**Alcoa Power Generating Inc. Tapoco Division**  
**Tapoco Hydroelectric Project (FERC No. 2169)**  
**Chilhowee Development Tailwater Fish Monitoring Plan**  
**August 2005**

## Appendix A: Consultation Record

## Appendix B: Comments Received on Draft Plan and APGI's Response

Figure 1

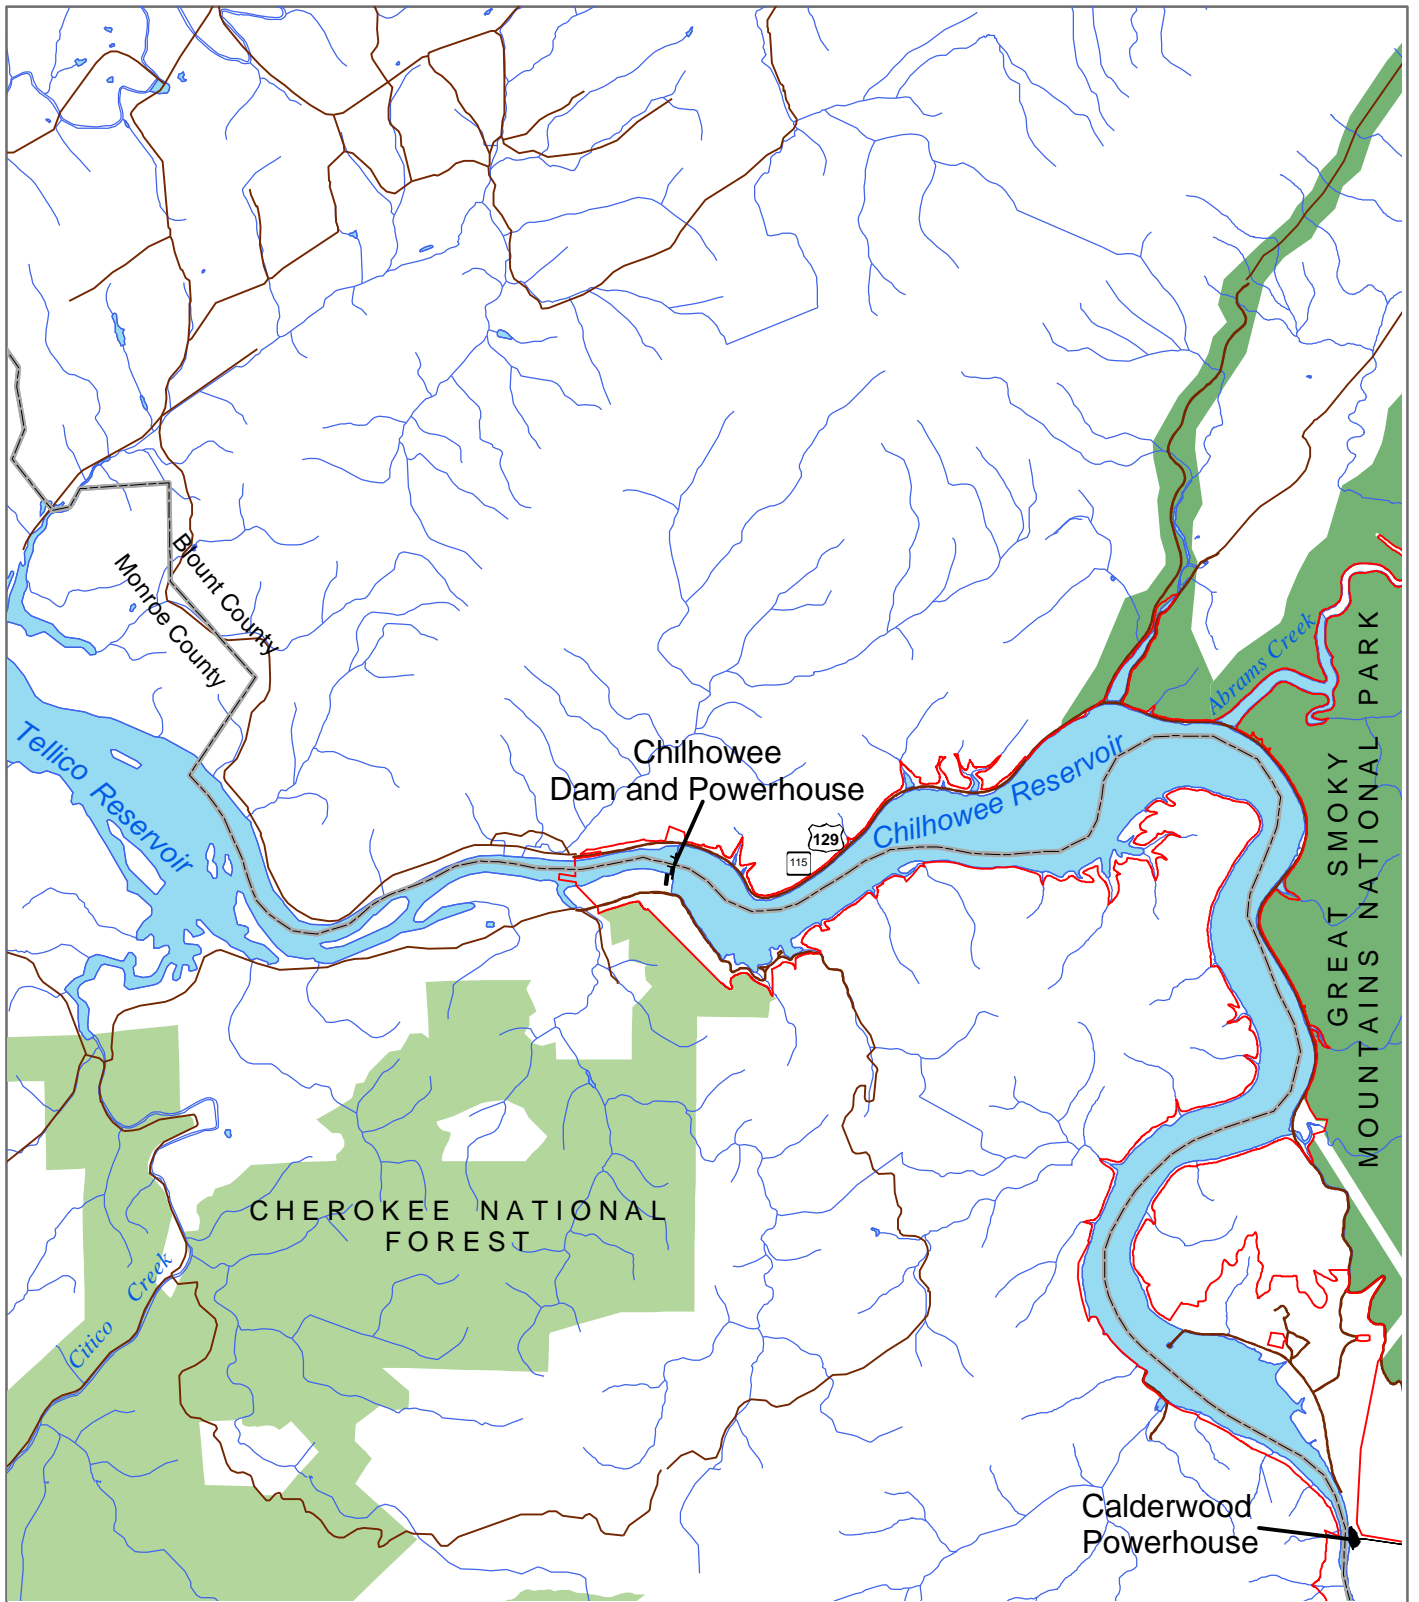
<p>Mark Cantrell, USFWS, E-mail Dated August 8, 2005</p> <p>At <u>1.2 Location and Setting</u>. Recommend rewording "<i>The first 3,000 feet downstream of the Chilhowee Powerhouse and Dam is located within the Project boundary</i>" to say "The Tapoco Project boundary extends 3,000 feet downstream of the Chilhowee Powerhouse and Dam."</p>	<p>Section 1.2 has been revised accordingly. See page 3.</p>
